# ComplexCalc-HW — Power Supply Review

This document summarizes the official power supply requirements of the STM32F411CEUx (datasheet DocID026289 Rev. 7, STMicroelectronics) for the **UFQFPN48** package, and compares them against what is currently routed in `design/ComplexCalc/ComplexCalc.kicad_sch` of the `UAA-F14/ComplexCalc-HW` repository. All reference figures and tables are direct captures from the official datasheet.

Figure 1: UFQFPN48 pinout — Figure 10, STM32F411xC/xE datasheet, p. 34

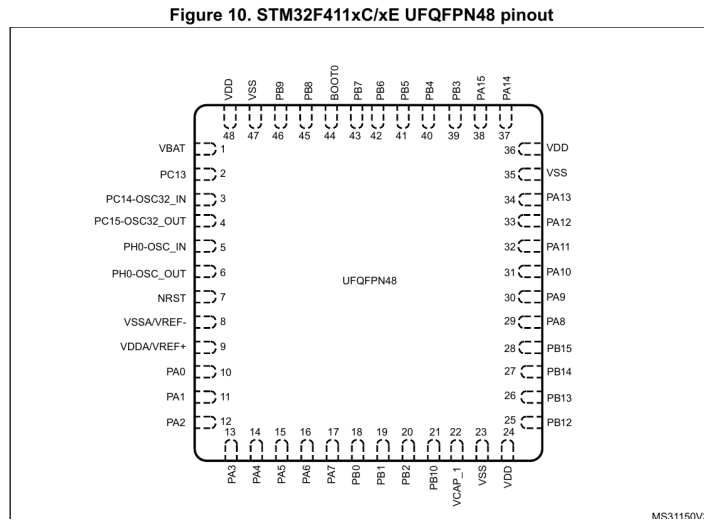
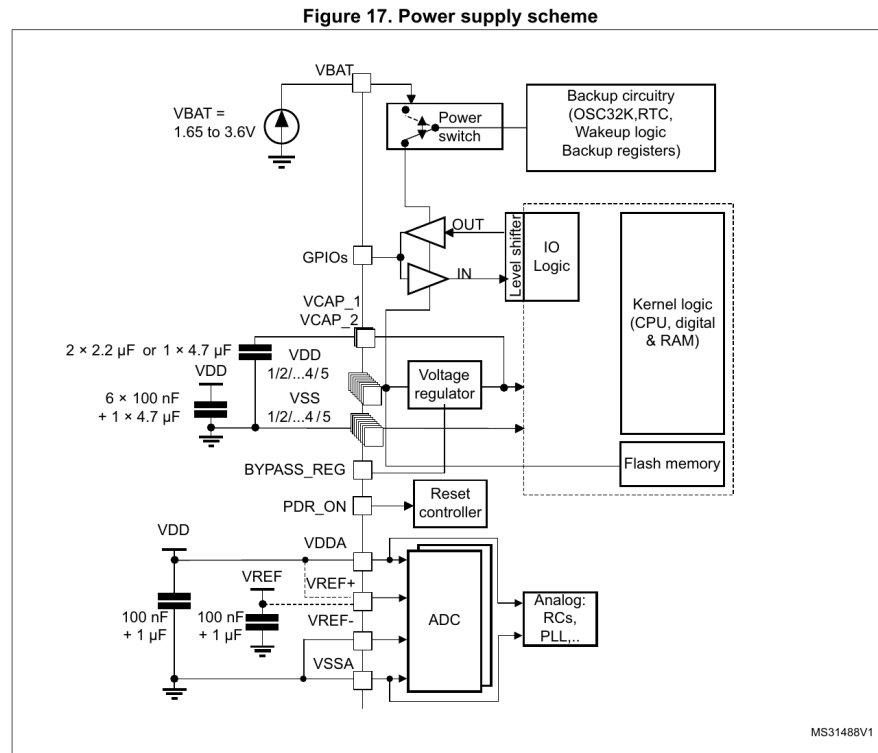
Figure 1 (Figure 10 of the datasheet, page 34) shows the exact pin assignment of the package used on this board. From it we confirm:

- **3 VDD pins:** 24, 36, 48
- **3 VSS pins:** 23, 35, 47
- **Only 1 VCAP\_1 pin** (pin 22) — this package does *not* bring out VCAP\_2 (that signal only exists on the LQFP100 and UFBGA100 packages)
- VBAT: pin 1
- VDDA/VREF+: pin 9 · VSSA/VREF-: pin 8
- NRST: pin 7 · BOOT0: pin 44
